MODIFICATION REQUEST:

***Clemton Park Village, 60 Charlotte Street,
Campsie
Former Sunbeam Factory
Concept Plan MP07_0106 MOD 5***

Secretary's Environmental Assessment Report
Section 75W of the
Environmental Planning and Assessment Act 1979

June 2014

Figure 2: Lot 31 Approved Layout

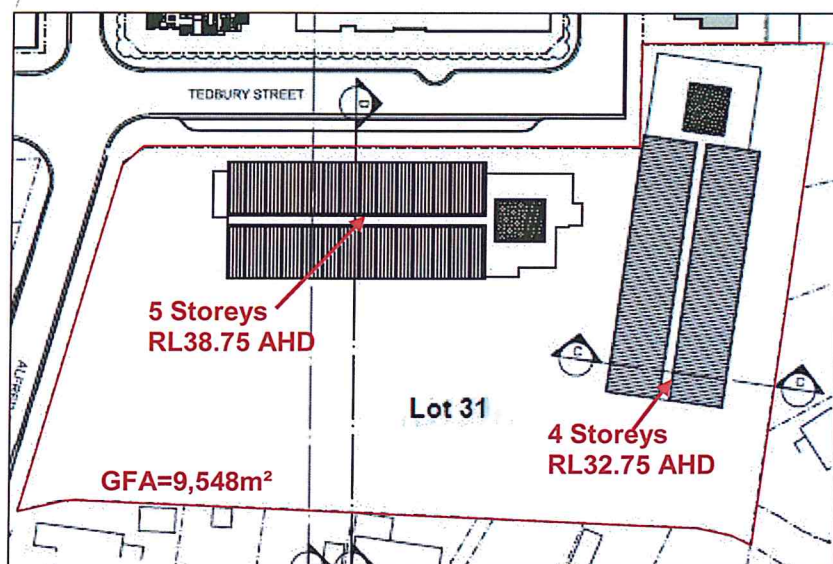
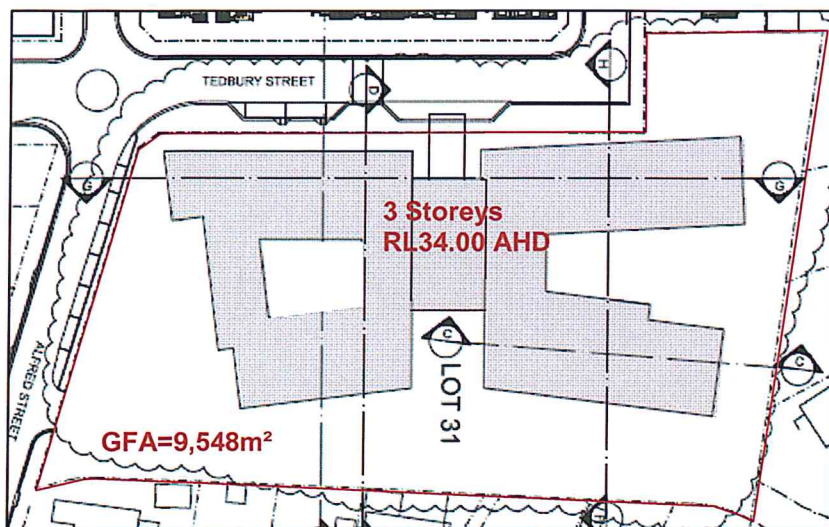
- amend building envelopes on Lot 31, replacing the approved 2, 4-6 storey building envelopes with a single building envelope (having a larger footprint) with a height reduced to 3 storeys.
- relocate the vehicular entrance from Tedbury Street (north) to Alfred Street (west); and
- amend the Statement of Commitments to reflect updated traffic and flooding reports submitted with this application.

The proposed modification involves a significant amendment to the building form whereby:

- two buildings are replaced by one, with a larger footprint;
- the overall height is reduced from 4-6 storeys to 3 storeys; and
- the overall floor space is reduced from approximately 9,548m² to 7,833 m².

The proposed changes to the built form are therefore considered to be appropriate.

Figure 4: Extract from indicative landscape plan

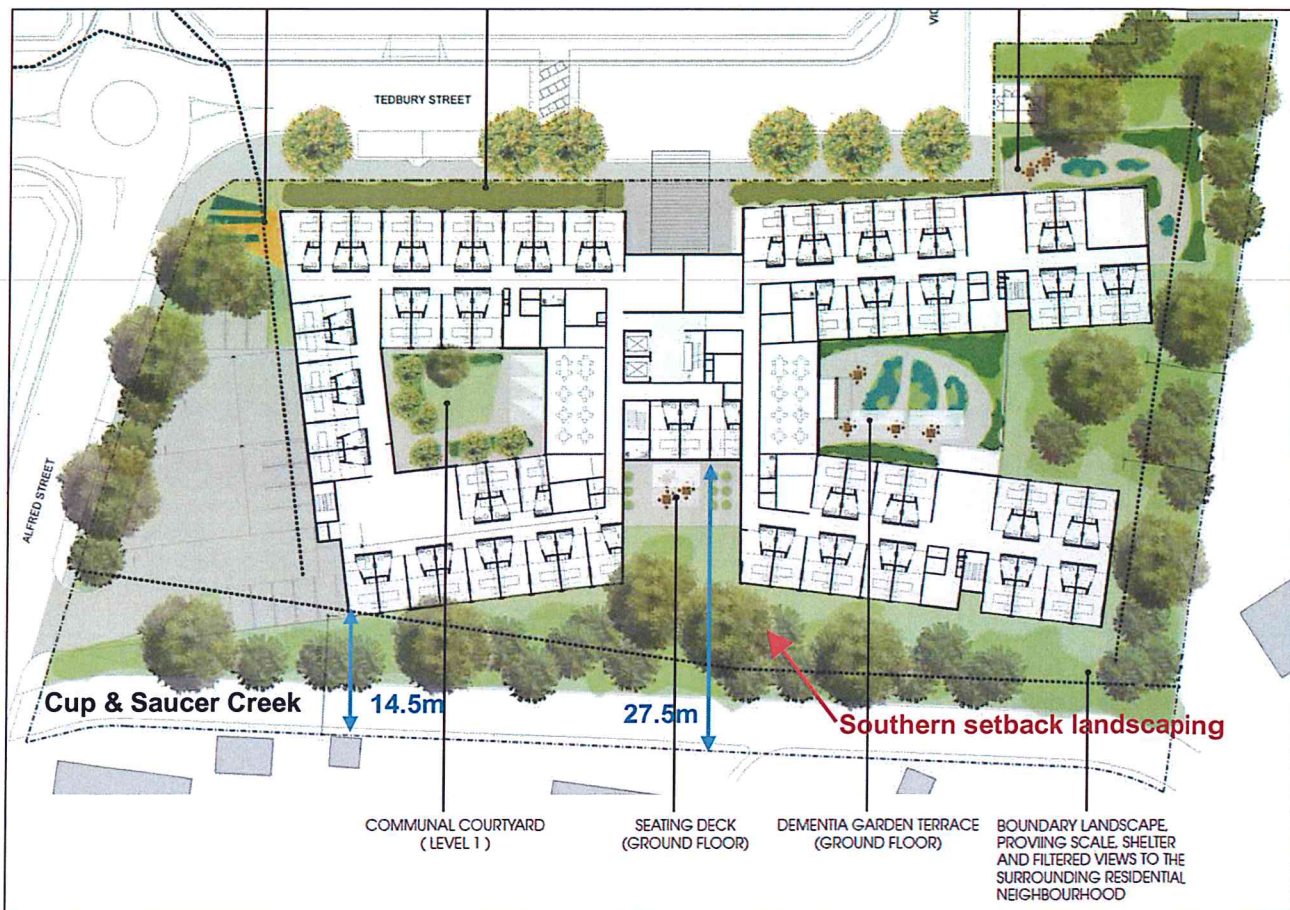
The proposal also seeks to reduce the setback to the southern boundary. The existing approved envelopes were located between 22 to 40 metres away from the southern boundary. The proposal involves a reduced setback ranging between 14.5m to 27.5m (refer to **Figure 4**).

Residents in Reid Avenue raised concern in relation to the impact of the reduced setback of the proposal to the southern boundary. In particular, concerns were raised with regard to:

- adverse overshadowing impacts;
- privacy and overlooking impacts; and
- overbearing and visual bulk impacts.

Although the building will be closer to the boundary than previously approved, it is considered that the significant reduction in height will also result in an overall improvement in visual impacts at the boundaries. The building design has been articulated, with deep recesses to reduce the appearance of bulk and scale along the Tedbury Street frontage and the rear aspect facing Reid Avenue. The Department also notes that the setbacks provide ample room for dense landscaping to screen the proposed development (refer to indicative landscape plan in **Figure 4**). This matter can be further addressed at the detailed DA stage with Council.

Flooding was a key issue addressed in the Department's assessment of the Concept Plan. Lot 31 has a storm water culvert located along the southern boundary (refer to **Figure 4**). The original buildings were located clear from the flood zone, however the proposed modification involves building envelope within the potential flood zone. The proponent's flood report advises that the highest 100 year flood level in proximity to the site is 21.3m AHD at the corner of Harp and Alfred Streets.

The Department notes that despite a reduction in setbacks, the proposal still comfortably complies with Council's DCP which requires a setback of 4 or 6 metres from the side and rear boundaries respectively.

In terms of privacy, the Department notes that the reduced height of the development will result in fewer opportunities for overlooking. The minimum 14.5 metre setback provides an adequate space for dense landscaping to screen the development and maintain the privacy of adjoining dwellings. In addition, this matter can be further considered by Council in the future assessment of a DA for the development.
